REVISIONS IN POWER RISER DIAGRAM
 No SCALE

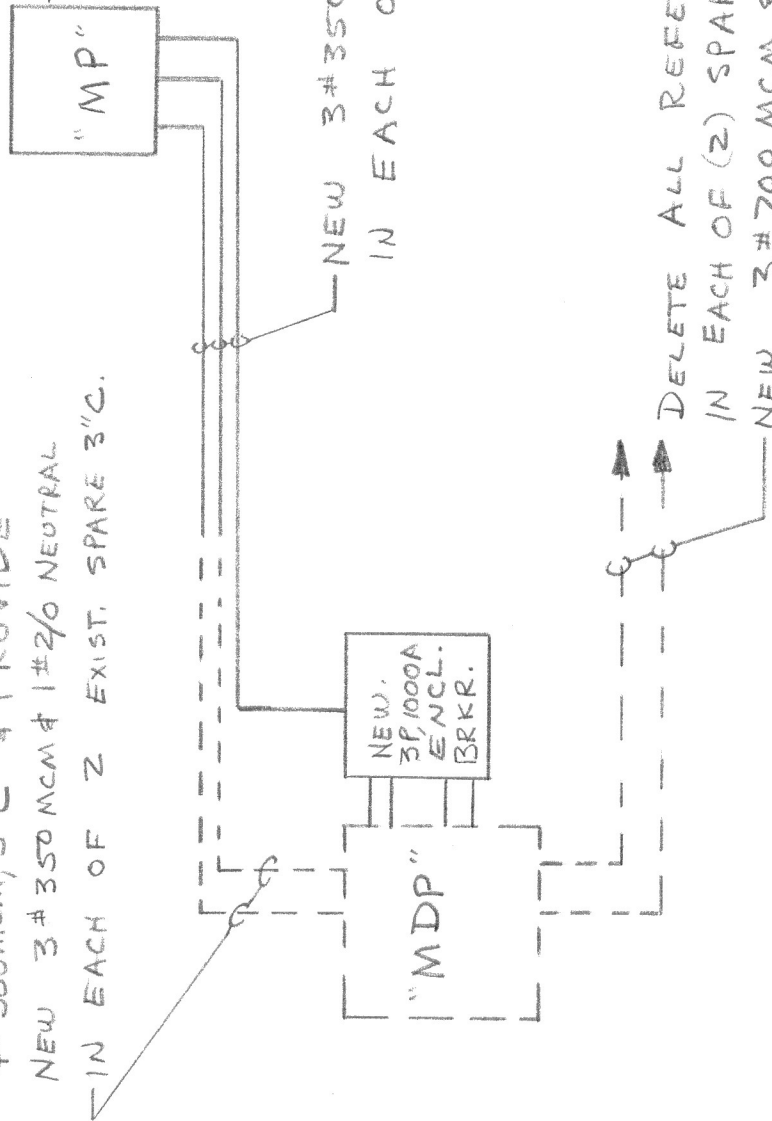
DELETE REFERENCE TO 600AMLO LUGS FOR 2# 300MCM/Ø IN PANEL "MP" & PROVIDE 1000AMLO LUGS FOR 3# 350 MCM/Ø IN "MP"

DELETE ALL REFERENCES TO 4# 300MCM, 3" C & PROVIDE NEW 3# 350 MCM & 1# 2/0 NEUTRAL IN EACH OF 2 EXIST. SPARE 3" C.
